LPA REF: HGY/2022/4522

PROPOSAL: DEMOLITION OF SINGLE STOREY GARAGE AND ERECTION OF A THREE STOREY OVER PART-BASEMENT, 2 BED SINGLE DWELLING-HOUSE

LOCATION: 1 FERRESTONE ROAD, HORNSEY, LONDON, N8 7BX

Photo 2 – Gap (garage & No 1 Ferrestone Rd)

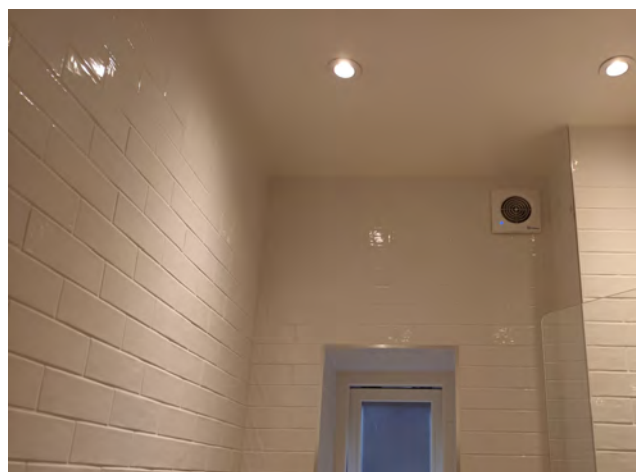
The gap between the garage wall and No1 Ferrestone Road decorative brickwork flank wall has a raised ground level. An existing side window, ventilation grilles and rainwater goods are sited on the flank wall of 1 Ferrestone Road.

Additionally, the proposed dwelling is wider than the existing garage, abutting the flank wall of No 1 Ferrestone Road, which as mentioned above has extract vents, rainwater goods and a window sited on this elevation.
